SERIAL: NLS-92-224

BRUNSWICK STEAM ELECTRIC PLANT, UNIT NOS. 1 AND 2
DOCKET NOS. 50-325 & 50-324/LICENSE NOS. DPR-71 & DPR-62
MISCELLANEOUS STEEL VERIFICATION PROGRAM

BRUNSWICK STEAM ELECTRIC PLANT, UNITS 1 AND 2
NRC DOCKET NOS. 50-325 & 50-324
OPERATING LICENSE NOS. DPR-71 & DPR-62
MISCELLANEOUS STEEL VERIFICATION PROGRAM

FIGURE 1

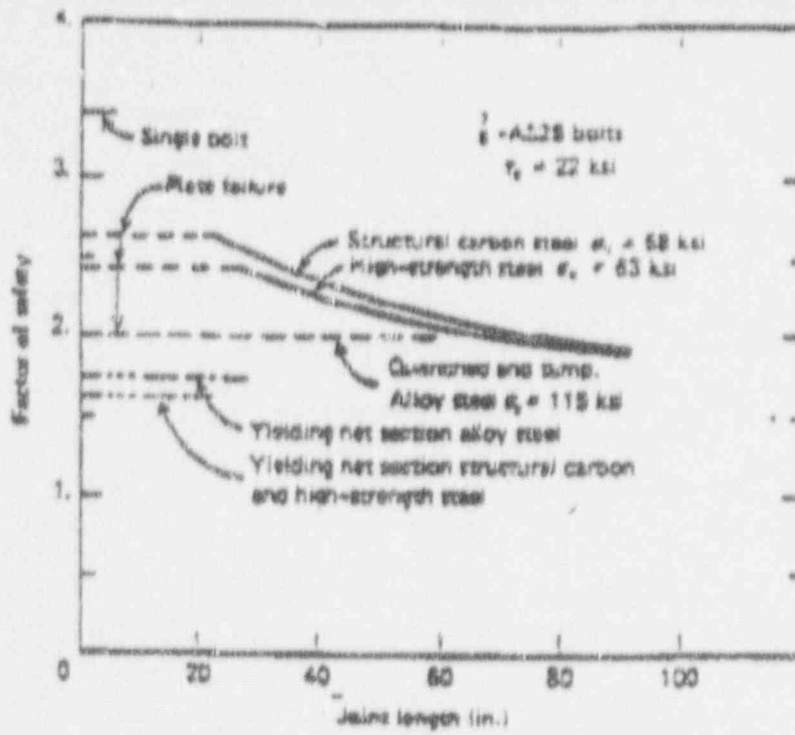
- Fillet Welds - As discussed in the Commentary to the 1970 AISC Specification, Section 1.5.3, "In earlier editions of the AISC Specification, working stresses were not given for fillet welds made with electrodes stronger than the E70 classification. The stresses that were given were known to be overly conservative for their recommended use with an E70 classification. Based upon tests (Reference 2), the allowable stress on fillet welds, deposited on 'matching' base metal or steel having mechanical properties higher than those specified for such base metal, is now given in terms of the specified tensile strength of the base metal."

As indicated in the commentary, there was no change specified in the design procedure, material specification or construction techniques and practices to utilize these higher values, just the recognition that "overly conservative" allowable stresses existed in the earlier specification which was corrected in later editions. An indication of the conservatism that exists for fillet welds based on the 1978 AISC Specification allowable stresses, is shown in the attached Figure 1, taken from the Steel Manual, 8th Edition, Page 4-73. This figure represents the results from a series of tests. As shown, the 1978 Specification fillet weld allowable stresses have a minimum factor of safety, as compared with the minimum yield value, of approximately two (2). Compared to the basic factor of safety for structural steel of 1.67, included in both the 1963 and 1978 Specifications, the 1978 Specification maintains excess safety margins for fillet welds. The higher

fillet weld allowable stresses will not control the overall margin of safety of the lower drywell platforms.

FIGURE 2

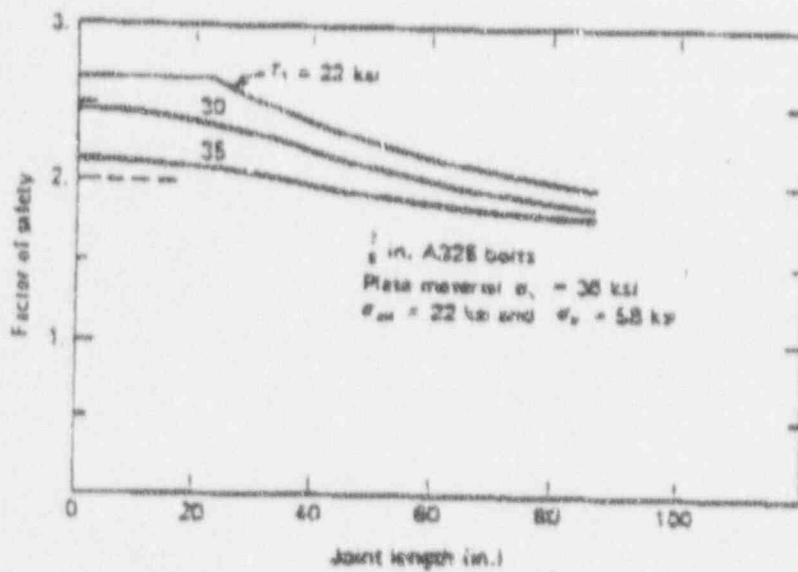
- Bolting - As discussed in the Commentary to the AISC Specification for Structural Joints, Section C4, included in the 8th Edition of the Steel Construction Manual: "in the current Edition of this Specification, significant increases have been made in the recommended working stresses for proportioning connections which function by resisting the transfer of shear between the connected parts in friction or bearing. While the research which supports the new provisions has been published from time to time in individual papers (some of it more than a decade ago), it was felt that the updating of working stresses, unchanged since initial adoption, should not be piecemeal. Therefore, a review looking toward a systematic presentation of the accumulated information within a single volume was initiated in 1970, under the direction of the Council. In restudying the research reported during the past two decades, the completed publication (Reference 3) has had as its goal the more reliable prediction of the behavior of various bolted connections under various kinds of loading."

"With the wealth of available data at hand, it has been possible, through statistical analyses, to adjust allowable working stresses to provide uniform reliability for all loading and joint types. The design of connections still is more conservative than that of the connected members of buildings and bridges by a substantial margin, in the sense that failure load of the fasteners is substantially in excess of the maximum serviceability limit (yield) of the connected material."

The allowable stresses included in the Specification for Structural Joints are consistent with those included in the 1978 AISC Specification for the Design, Fabrication and Erection of Structural Steel for Buildings. As indicated in the Commentary, this increase in allowable stresses does not require any change to the design approach, material specifications, or construction techniques and/or practices that would have been used for designs made to the 6th Edition Steel Manual. Figure 2 shows test data (taken from Reference 3) indicating that, based upon the 1978 Specification, the Factors of Safety for the bolting continues to exceed the allowable factor of safety for major axis bending. Therefore, increases in bolting allowable stresses through use of the 1978 Specification will not reduce the controlling margins of safety.
